Access Compliance Report

Public Rights-of-Way

(Curb Ramps)

| Intersection ID: 10018432 | Main Street: WITHAM PASSAGE | Cross Street: N/A | Location: E |

| ADA ID: E74FE6F5E17D | Ramp Type: Para | Initial Pass/Fail: Fail | Overall Compliance: No |

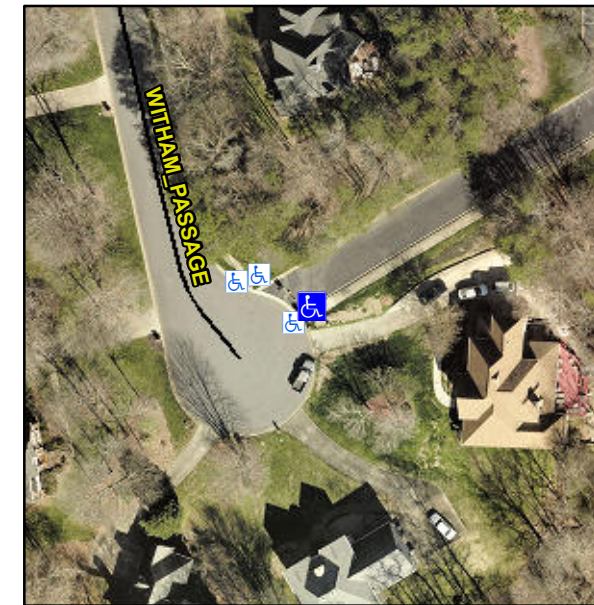
R304.3.2, R304.5.3

| Compliance | Description | Data | Compliance | Description | Data |
|------------|----------------------|-------|------------|-----------------------------|------|
| No | Ramp Slope LT (%) | 15.3 | No | Ramp Slope RT (%) | 12.5 |
| Yes | Ramp XSlope LT (%) | 1.1 | No | Ramp XSlope RT (%) | 4.3 |

Remove & Replace Entire Ramp.
